KPA500 KIT ASSEMBLY MANUAL ERRATA

Rev F9-3, July 1, 2020

Figure 19. Installing the Fan

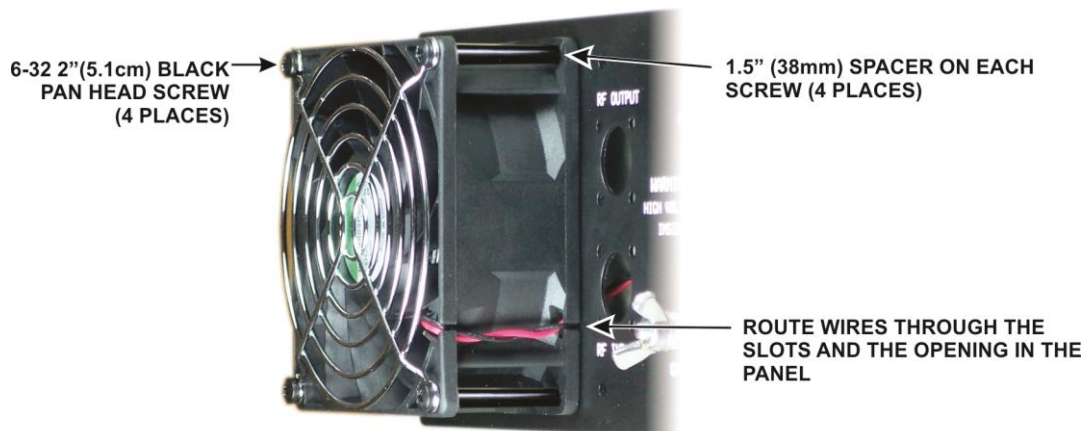
2. **Page A8 (Parts List):** The red connector board, part number E980178, is changed to new part number, E850851. The new board is green and the fit and function is the same as the previous Terminal Strip Board.
3. **Page A8 (Parts List):** Spacer information is correct as shown in the manual. Item 3 below is incorrect, see correction below.
4. **Page 17, Figure 19:** Replace the figure with the following showing spacers placed on the mounting screws between the front and rear corner tabs on the fan housing.
